January 14, 2013

RE: 11 Linden Avenue Somerville, MA. - Parking Memorandum #2

Figure 1 - Parking Layout (12-7-12)

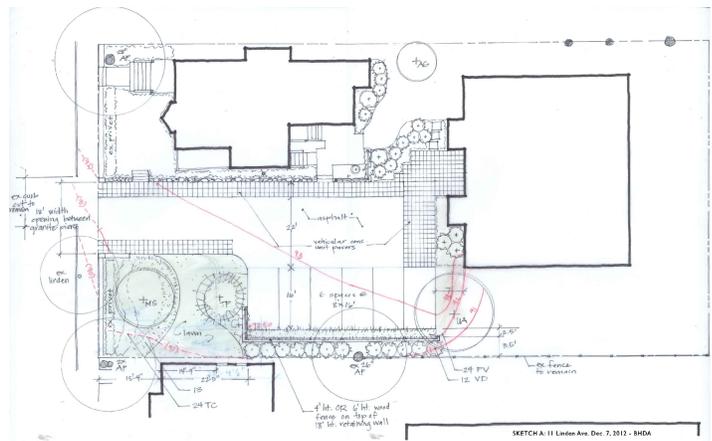
Six on-site parking spaces are proposed; however, based on its most recent negotiations with the immediate abutter, Linden Tree Realty Trust now proposes that all six parking spaces be fully compact parking spaces (8'x16'). The previous parking memorandum was written to confirm that the compact length of each parking space (16') was practical and safe. This parking memorandum has been prepared to assist the City staff in determining whether providing a compact width of 8 feet would be viable or have any inherent safety issues and to explain the maneuverability of the parking stall located furthest from the street.

The updated parking plan includes a bituminous concrete surface for the parking stalls and the center of the parking aisle. In addition, concrete pavers, capable of accommodating vehicle loads, are provided along the sides and rear of the parking aisle. The concrete pavers are provided to highlight where pedestrians should access the buildings as well as to give the appearance of a smaller driveway and parking area. The pavers provide the added benefit of allowing additional maneuverability for drivers entering or exiting the site or the parking stalls.

Because the pavers are flush with the bituminous concrete section of the parking area, the parking layout provides for a wider parking aisle than previously proposed in September of 2012. This increased maneuverability applies to the last parking stall as well. Even though pavers are positioned behind this parking stall, there will be no impact on the ability for a driver to use this parking space.

The pavers are merely placed there to give the appearance of a larger entry walk and a smaller parking area without actually compromising the functionality of the last parking stall.

It is viable to reduce the width of the parking stalls from 9 feet to 8 feet because it is commonly accepted that 8' wide parking spaces are allowed as compact parking spaces both by the Somerville Zoning Ordinance (SZO) and by nationally recognized transportation publications such as the Institute of Transportation Engineers (ITE) Transportation Planning Handbook, 3rd Edition and Traffic Engineering Handbook, 6th Edition. It should be noted that although commonly accepted, the SZO only allows for 20% of the spaces to be compact.

In addition, the narrower parking stall is viable if and only if a parked vehicle can be fully accommodated within the parking stall. If not, the full complement of parking spaces (6) may be less likely to be used resulting in a driver opting to park in the street instead. However, 8-foot wide parking spaces are more likely to be fully utilized in a residential setting versus say a retail setting (as explained above). Based on several top car manufactures specifications, typical vehicle widths for each of the common vehicle classifications are listed below:

The largest vehicle classification such as large SUVs have a typical width slightly larger than above (~6.5'), however, with the increased popularity of compact cars and sub-compact cars due to fuel efficiency and environmentally conscience buyers, wider vehicles are less likely. As illustrated above, an 8-foot wide parking stall will likely allow for 2 to 2 ½ feet of excess space per stall, resulting in approximately 4 to 5 feet of space between each parked vehicle. Even in the unlikely event of the worst case, when two large SUVs are parked side by side, there will still be 3 feet of space which will facilitate opening a car door. Therefore, the 8-foot wide parking stalls should be able to safely accommodate a parked vehicle and each of the six spaces will likely be fully utilized.

This parking memorandum (along with the first) demonstrates that the proposed parking layout which includes 6 - 8'x16' sized parking spaces is a viable parking plan. In addition, this

memorandum has demonstrated that providing narrower parking spaces, as opposed to standard width parking spaces, do not increase the likelihood of any safety issues.
